Re: Juan Cuevas Ramirez & Gabriela Alfaro
Comal Hills Unit 1 Lot 200 Block 5
Application for Permit for Authorization to Construct an On-Site sewage Facility

106243

Re: Comal Hills Unit 1 Lot 200 Block 5, Permit 106243
Application for Permit of Authorization to Construct On-Site Sewage Facility (OSSF)
and License to Operate

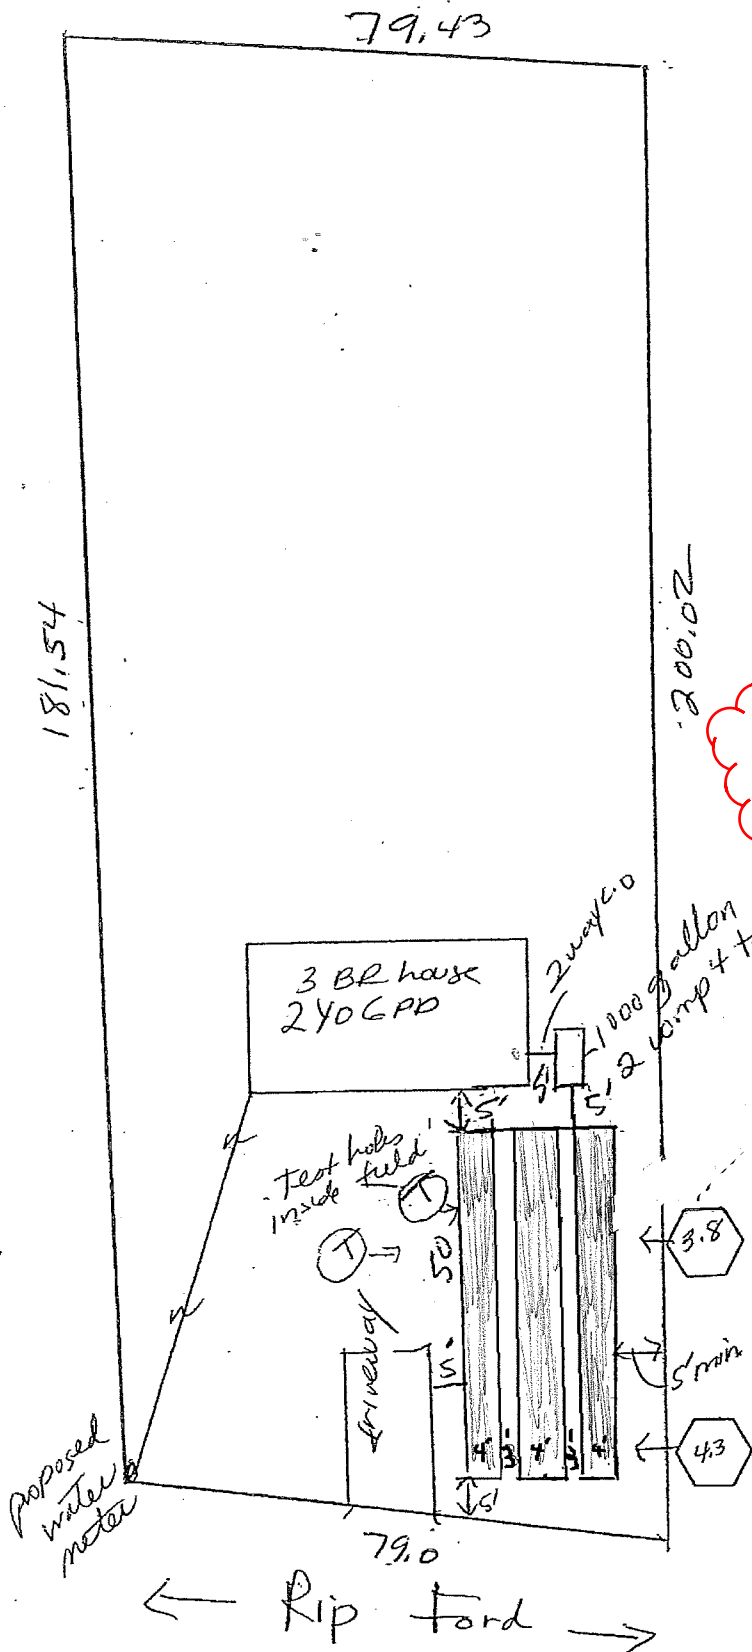
See attached design submitted to our office 11/22/17, which shows 4 ft. wide excavations. For 6 ft. wide excavations, 2 pipes are required in each trench. Be advised a final inspection has not been completed and the License to Operate has not been issued.

1. 1200 sq. ft. is required but only 924 sq. ft. designed.
2. Revise as needed and resubmit.

Thanks--I just noticed you had already mailed me the design with Brenda's letter. Sorry. Cruz Aguinana put that in and I (and he) thought it passed final inspection. It is 1236 square feet of drain field--I think Brenda forgot to calculate the sidewall absorption. The excavations were 6' x 50' on the bottom, but they also had 2' x 50' of sidewall absorption on each side, which was 100 square feet times 3 excavations, and ends of 6' x 6 ends =36. Sincerely, Virginia

3 excavations 6' x 50' x 5'
 with sidewalls
 $8 \times 50 + 12 \times 3 = 1236$
 1 row perforated
 pipe in
 each
 3' minimum
 between
 excavations

106243

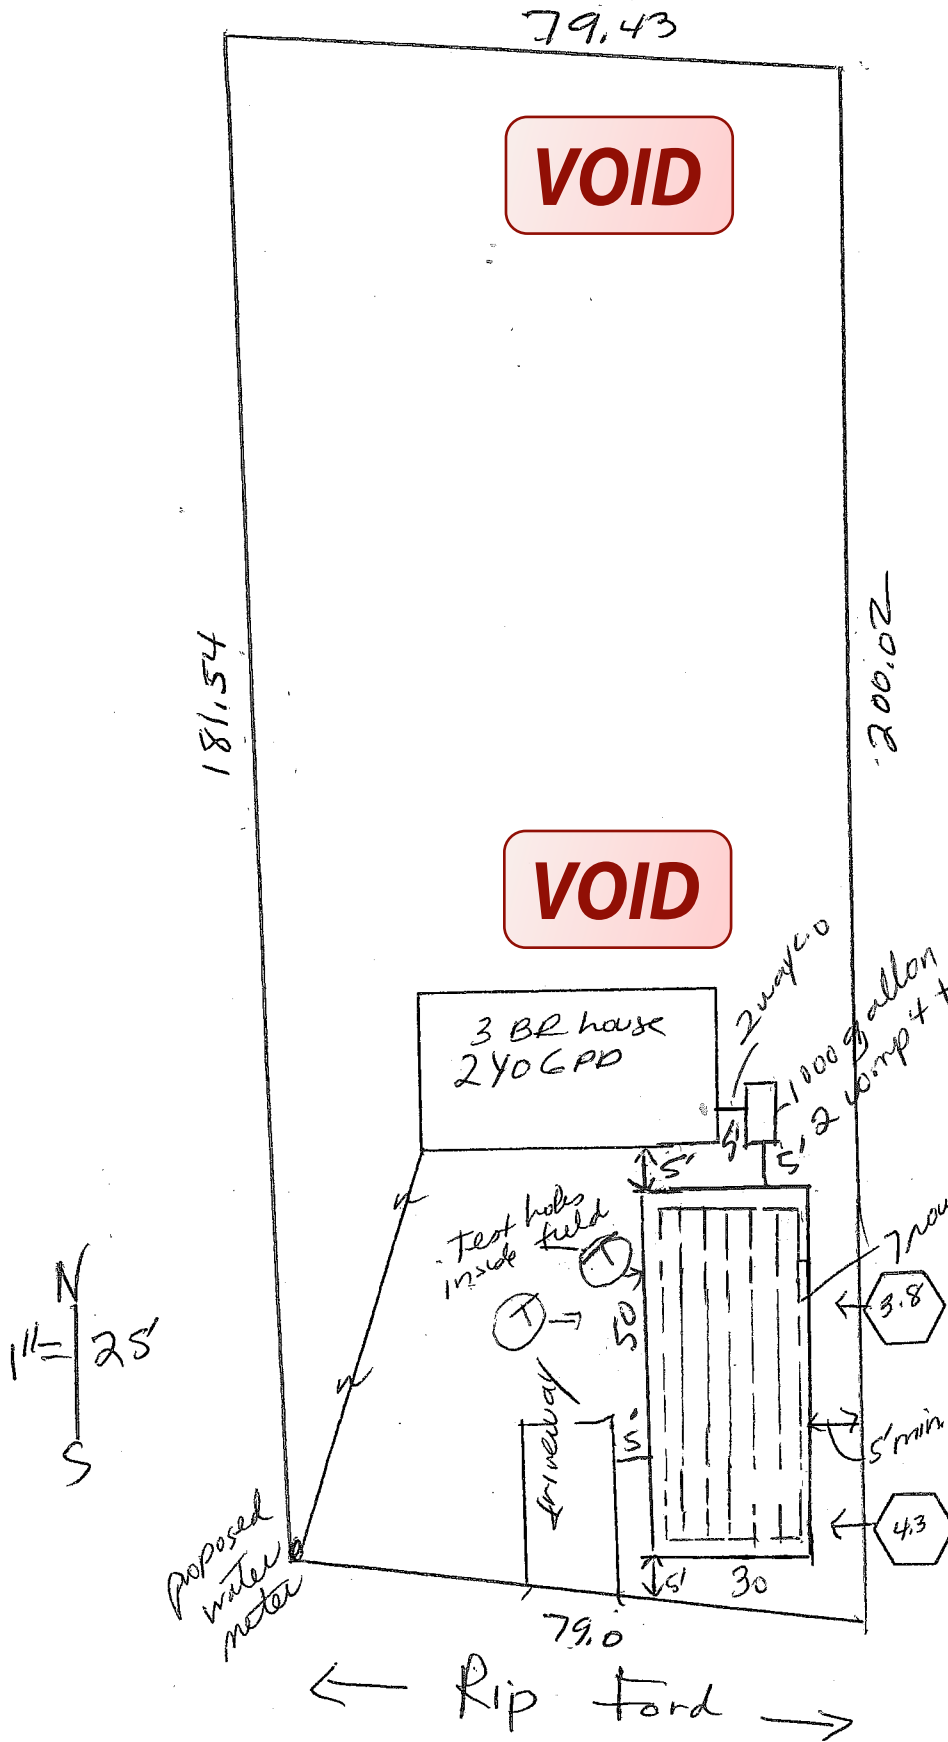
- ✓ The designer must clarify the observation notes on the OSSF Soil Evaluation form.
- ✓ The designer must re-evaluate the system sizing. Based on the soil evaluation, the system is undersized. Based on the existing soils class III sizing must be utilized.
- ✗ The designer must show the inside dimensions of the excavation on the design. Revised to standard pipe and gravel
- ✗ The designer must submit a profile of the soil substitution excavation.
- ✗ The designer must indicate the type of imported soil to be placed in the excavation.
- ✗ The designer must evaluate soils to 2 ft. below the bottom of the soil substitution excavation and record this information on the soil evaluation.
7. Revise above as needed and resubmit.

3 BR house under
2500 sq living space

= 240 GPD
/ 2 (Class 3 Soil)

1200 sq required
28 x 50

= 30 x 50 + 56 = 1556
actual

7 rows of perforated
pipe 2' from sides
& between rows
